Betreff: IEEE 802.1Q, CFM CCM Protocol, Faster Intervals?

**IEEE 802.1Q CFM CCM
Interval -
Extension proposal**

Change Proposal for IEEE 802.1Q CFM CCM Intervals

Table 21-15—CCM Interval field encoding

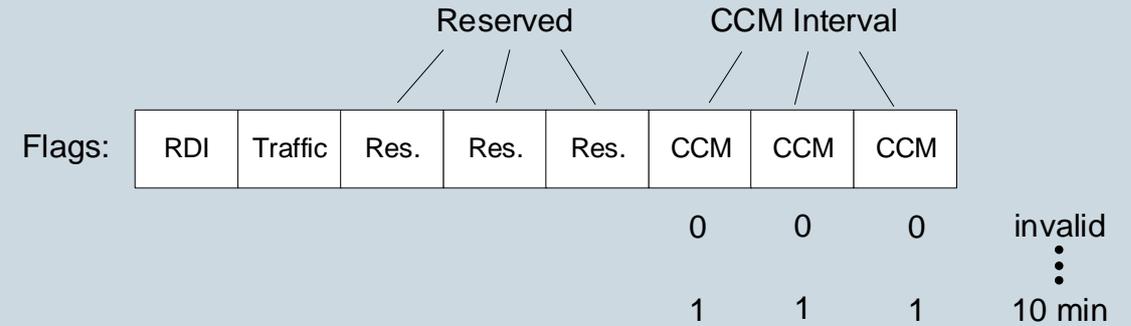
Change Proposal for IEEE 802.1Q CFM CCM Interval - Proposal for Interval times coding extension

- To be able to code additional faster Intervals, it is proposed to use two of the reserved bits for CCM Interval extended¹:

Reserved		CCM Interval extended		CCM Interval			
Flags:	RDI	Traffic	Res.	CCM	CCM	CCM	CCM	CCM	
				0	0	0	0	0	invalid
				0	1	0	0	0	0.1 ms
				1	0	0	0	0	1 ms
				1	1	0	0	0	2 ms

¹This involves also slight text changes e.g. here: chapter 20.1 “The loss of three CCMs can be detected in as little as 10.8 ms (see Table 21-15).”

-> “...in as little as 0.33 ms”
